## DEVELOPMENT APPLICATION ASSESSMENT REPORT

<b>Application Number:</b>	DA2022/1454
----------------------------	-------------

<b>Responsible Officer:</b>	Thomas Burns
<b>Land to be developed (Address):</b>	Lot 10 DP 28920, 8 Surf Side Avenue AVALON BEACH NSW 2107
<b>Proposed Development:</b>	Demolition works and construction of a dwelling house including swimming pool
<b>Zoning:</b>	C4 Environmental Living
<b>Development Permissible:</b>	Yes
<b>Existing Use Rights:</b>	No
<b>Consent Authority:</b>	Northern Beaches Council
<b>Land and Environment Court Action:</b>	No
<b>Owner:</b>	Richard Lindsay Seeto Louise Jennifer Seeto
<b>Applicant:</b>	Richard Lindsay Seeto

**Figure 1:** *ground floor front setback non-compliance highlighted in yellow*

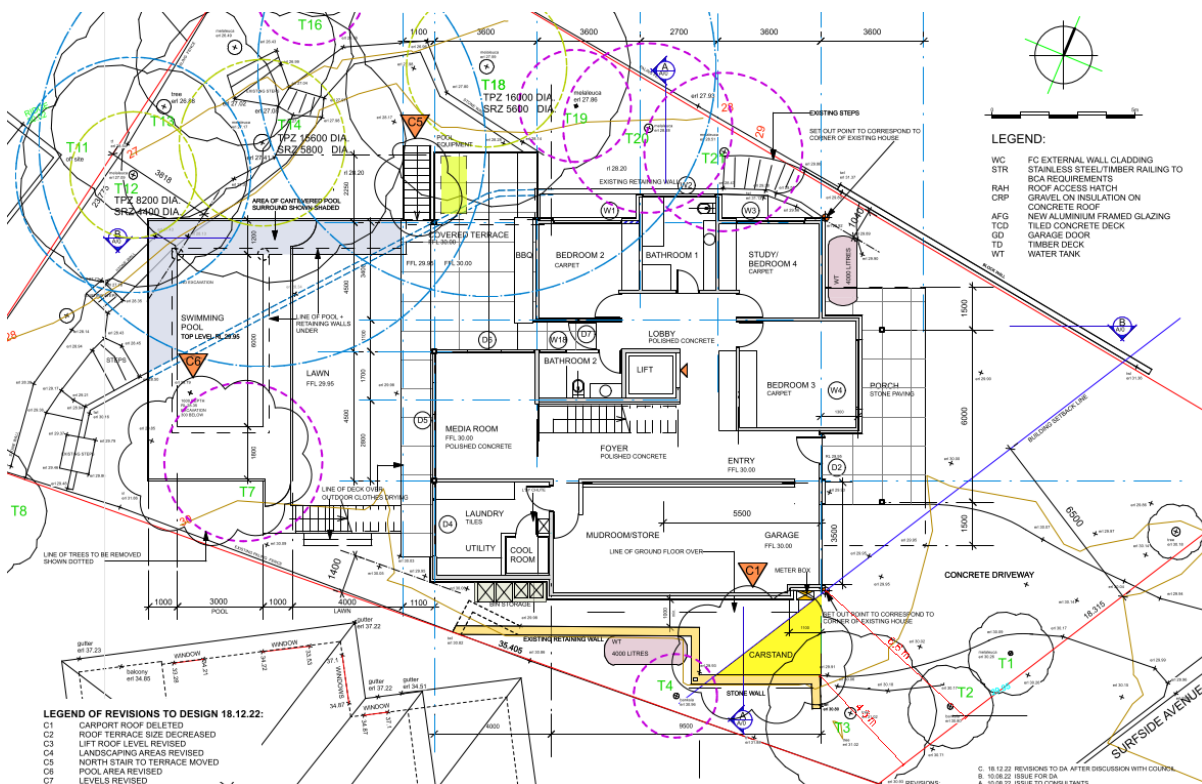
The control requires development to be setback at least 6.5m from the front boundary. The proposed open hardstand parking space and corner of the first floor decking encroaches into the 6.5m front setback area, as depicted in Figures 1 and 2 below.

It is noted that the front building line of the proposed dwelling house is generally consistent with that of the existing dwelling house. Furthermore, it is noted that the facade of the dwelling house complies with the front setback requirement.

**Figure 3: northern side setback and rear non-compliance highlighted in yellow**

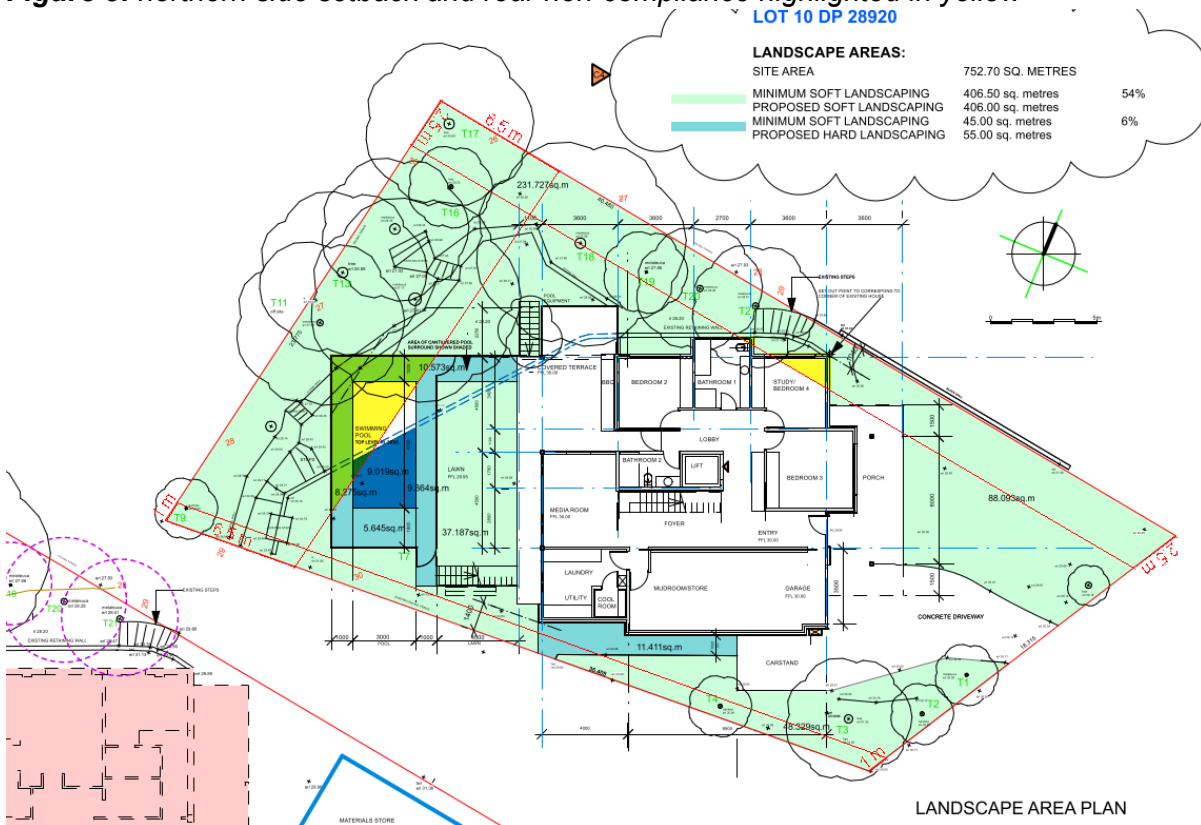
The control requires development to be setback 2.5m from one side boundary and 1m from the other side boundary. The proposal complies with the 1m side setback requirement, however a small portion of the northern elevation of the dwelling house encroaches into the 2.5m side setback area. Figure 3 below highlights the area of non-compliance.

Furthermore, the proposed swimming pool area also encroaches into the prescribed 6.5m rear setback area, as demonstrated in Figure 4 below.

**Figure 4: northern elevation envelope breach**

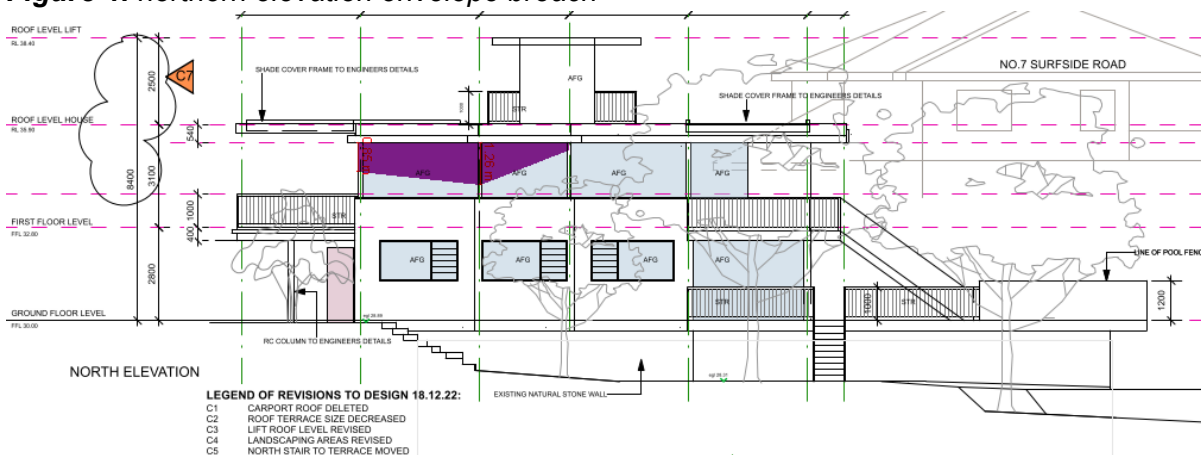
The control requires development to remain within a prescribed side building envelope that is determined by projecting planes at 45 degrees from a height of 3.5m above the existing ground level at side boundaries.

Portions of the northern and southern side elevations protrude outside of the prescribed side envelope requirement on the northern and southern elevations of the dwelling house. Figures 4 and 5 below depict the extent of non-compliance.
